UNITED STATES PATENT AND TRADEMARK OFFICE

APPLICATION NO.	FILING DATE	FIRST NAMED INVENTOR	ATTORNEY DOCKET NO.	CONFIRMATION NO.
10/690,147	10/21/2003	Stephen H. Canonico	A3 , 041	3912

Office Action Summary

DETAILED ACTION

Figure 1: Korsmo US 2,800,798

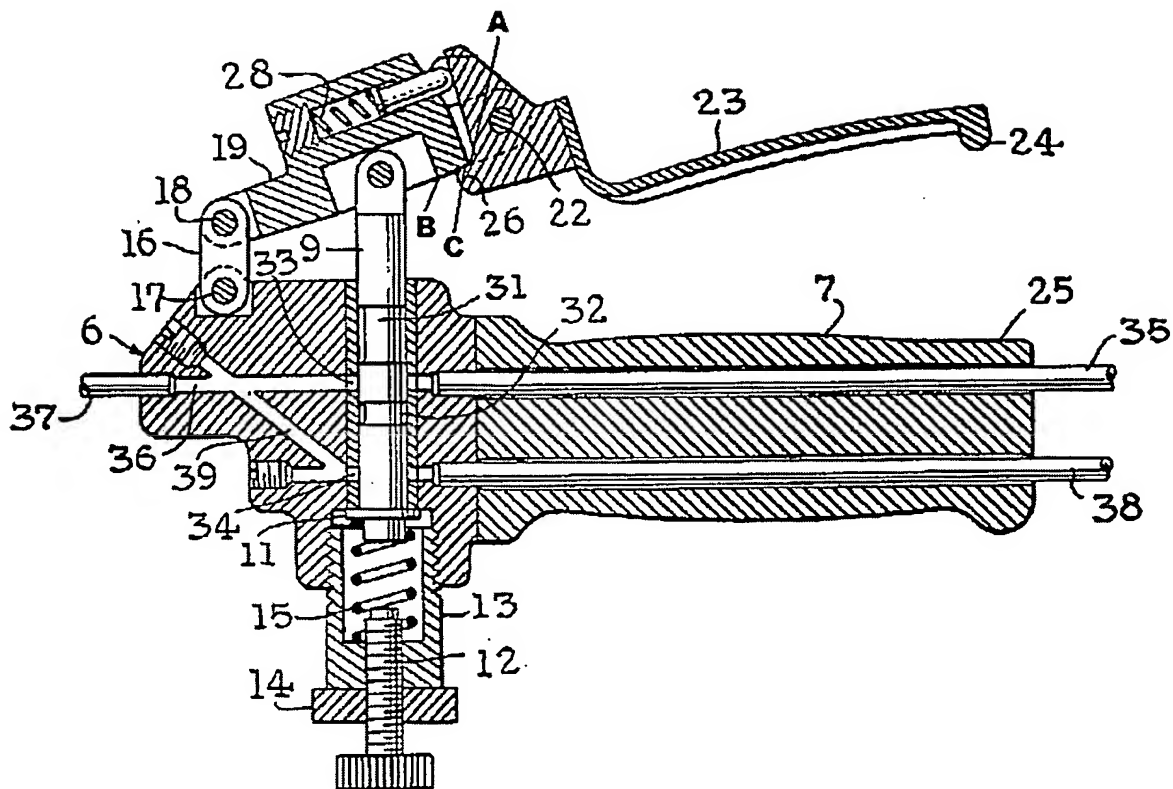
Claim 1 is rejected under 35 U.S.C. 102(b) as being anticipated by Korsmo US 2,800,798.

Korsmo shows in Figure 1 below, a lever body (23) mounted for pivoting movement about an axis from a released position, to an actuated position; said lever body having a rearward first fulcrum surface (A) and a rearwardly-extending lip (26) proximate said first fulcrum surface; a lever arm (19) having a forward edge portion (B) and a second fulcrum surface proximate said forward edge portion (C), said first fulcrum surface and said second fulcrum surface being adapted for mating engagement when said forward edge portion is engaged under said lip; and tensioning means (28) for applying a contraction force between said first fulcrum surface and said second fulcrum surface that biases said first and second fulcrum surfaces into mating engagement.

Figure 2: Brainard US 6,516,682

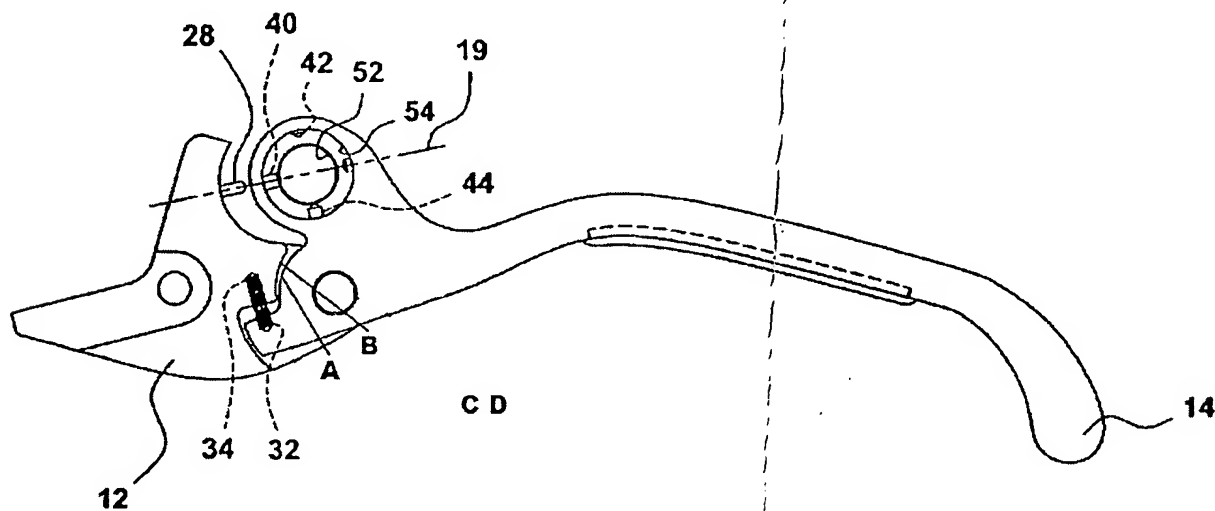
Brainard shows in Figure 2 below, a hand operated jointed control lever with first and second mating surfaces (A, B) that are cylindrically concave and convex.

It would have been obvious to a person of ordinary skill in the art at the time the invention was made to modify the lever assembly disclosed by Korsmo such that the mating surfaces be cylindrically concave and convex in view of Brainard to provide a larger contact area therefore allowing for a better distribution of force and lessening the stress on the mating components.

Figure 3: Sogoian US 3,940,165

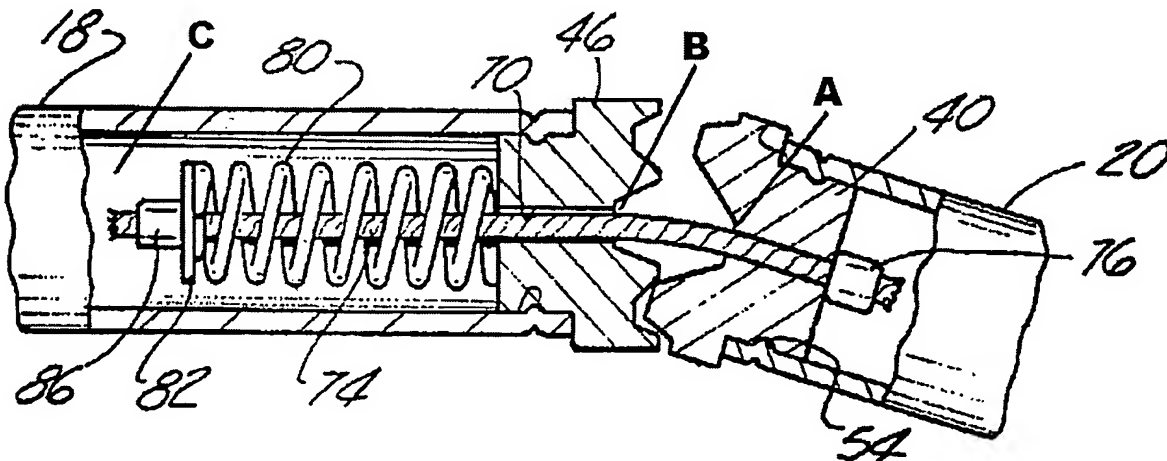
Sogoian shows in Figure 3 below a tensioning cable (74) passing through the first (A) and second (B) fulcrum surface, said tensioning cable having a first end (76) and a second end (86), said first end being secured to said lever arm (20); and a compression coil spring (80) interposed between the second end of the tensioning cable and the lever body within a cavity (C) formed within said lever body (18), and the tensioning cable passing axially through the coil spring.

It would have been obvious to a person of ordinary skill in the art at the time the invention was made to modify Korsmo such that the tensioning means comprises a cable passing through a coil spring in view of Sogoian to allow for a greater range of motion when the lever body is angularly deflected relative to the lever arm (Sogoian, ABSTRACT, lines 5-6).
